VIRGIL C. SUMMER NUCLEAR STATION, UNIT NO. 1

AMENDMENT TO FACILITY OPERATING LICENSE

Amendment No. 27
License No. NPF-12

ATTACHMENT TO LICENSE AMENDMENT NO. 27

FIGURE 3.9-1 MINIMUM REQUIRED FUEL ASSEMBLY EXPOSURE AS A FUNCTION OF INITIAL ENRICHMENT TO PERMIT STORAGE IN REGION 2

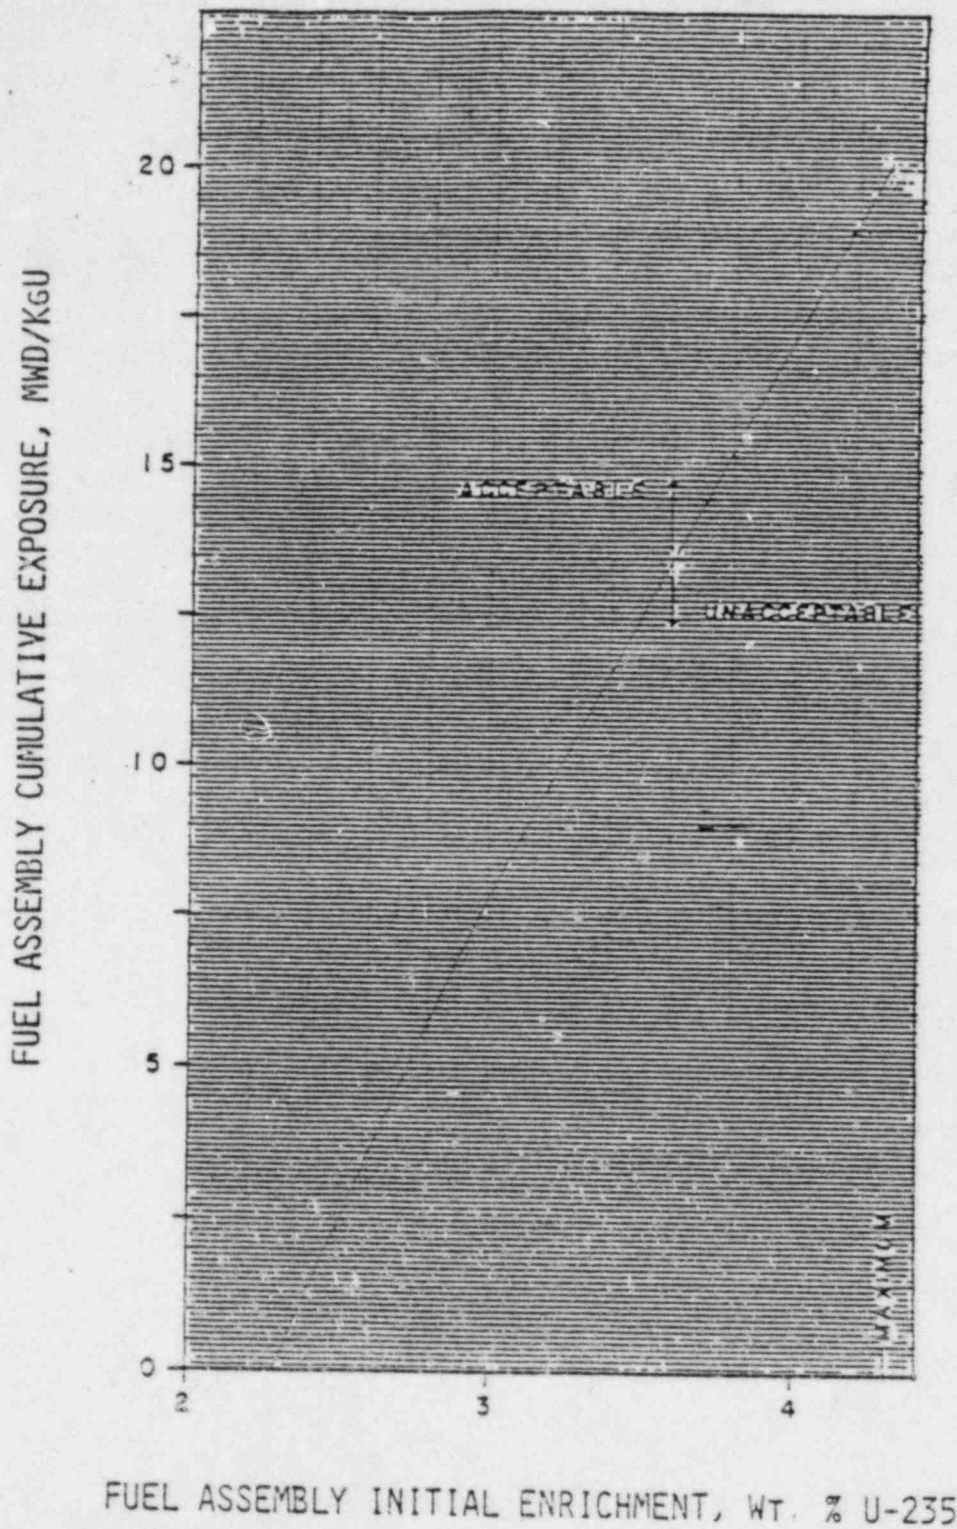
3.9.12 The combination of initial enrichment and cumulative exposure for spent fuel assemblies stored in Regions 2 and 3 shall be within the acceptable domain of Figure 3.9-1 for Region 2 and Figure 3.9-2 for Region 3.
